GLISSON ADDITION TO PINE HILL DRIVE SUBDIVISION

APPLICATION NUMBER 15 DATE June 21, 2007

REQUEST Subdivision

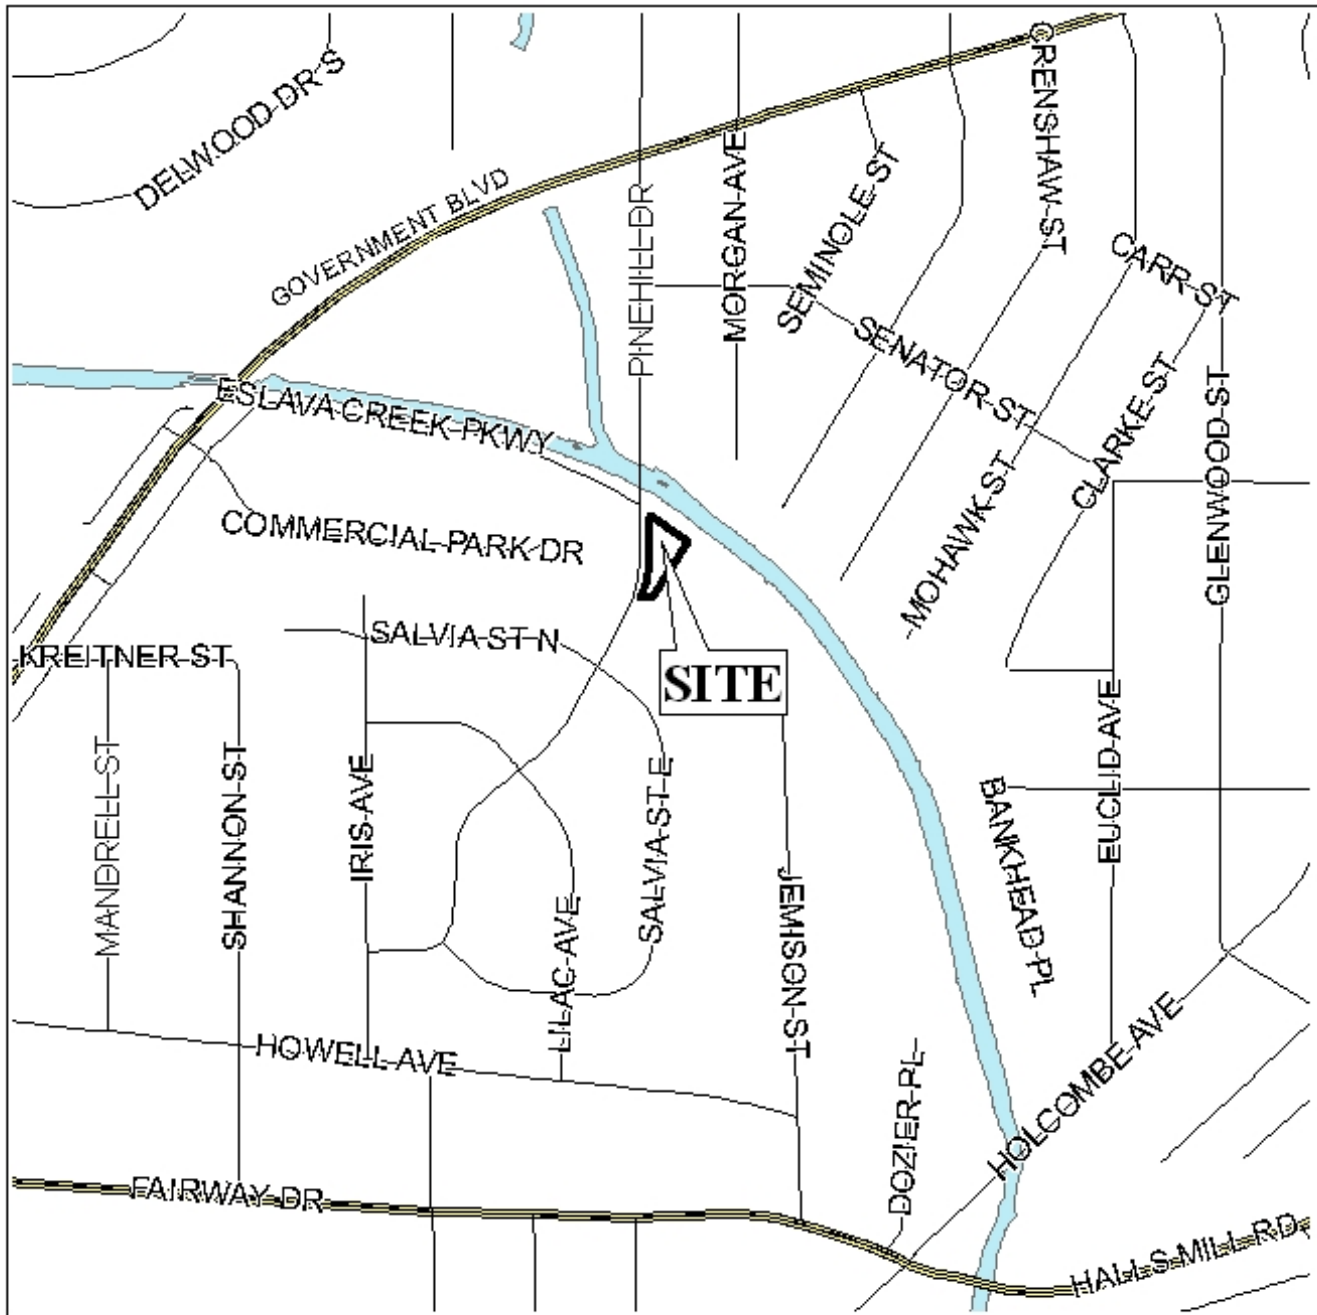
Engineering Comments: Show limits on x-shaded flood plain. Show minimum finished floor elevation on each lot. It is the responsibility of the applicant to look up the site in the City of Mobile (COM) GIS system and verify if NWI wetlands are depicted on the site. If the COM GIS shows wetlands on the site, it is the responsibility of the applicant to confirm or deny the existence of wetlands on-site. If wetlands are present, they should be depicted on plans and/or plat, and no work/disturbance can be performed without a permit from the Corps of Engineers. Must comply with all storm water and flood control ordinances. Any work performed in the right of way will require a right of way permit.

Both the proposed Lot 1 and the proposed Lot 2 have frontage on Pinehill Drive, and neither of the proposed lots are corner lots. Pinehill Drive is a minor street with adequate 50-foot right-of-way. Therefore, no dedication should be required, however, the plat should be modified to reflect the current right-of-way of Pinehill Drive. Given the amount of street frontage as illustrated, the site should be limited to the existing curb cuts.

The 25 foot minimum building setback is not shown, and should be illustrated as per Section V.D.9 of the Subdivision Regulations. The structures on the proposed lots have adequate front yard setbacks.

Both of the proposed lots exceed the minimum lot size, however, the lots should be labeled with their size in square feet, or a table provided on the plat with the same information.

Lastly, it appears that the residential structure on the proposed Lot 1 may be a duplex. This is evidenced by the fact that there are two addresses shown for the structure on the City of Mobile GIS (615 and 617 Pinehill Drive), and the fact that the structure is shown both on GIS and the preliminary plat to have two driveways. The applicant should be advised that use of the structure as a duplex or multi-family residential dwelling unit would be prohibited unless the applicant could provide non-conforming use documentation, petition for rezoning or a Board of Zoning Adjustment Use Variance.

- 1) depiction of the 25 foot minimum building setback on both lots as per Section V.D.9 of the Subdivision Regulations;
- 2) a note on the final plat limiting the site to the existing curb cuts;

- 3) labeling of each lot with size in square feet, or a table provided on the plat with the same information;
- 4) Compliance with Engineering Comments (*Show limits on x-shaded flood plain. Show minimum finished floor elevation on each lot. It is the responsibility of the applicant to look up the site in the City of Mobile (COM) GIS system and verify if NWI wetlands are depicted on the site. If the COM GIS shows wetlands on the site, it is the responsibility of the applicant to confirm or deny the existence of wetlands on-site. If wetlands are present, they should be depicted on plans and/or plat, and no work/disturbance can be performed without a permit from the Corps of Engineers. Must comply with all storm water and flood control ordinances. Any work performed in the right of way will require a right of way permit*).
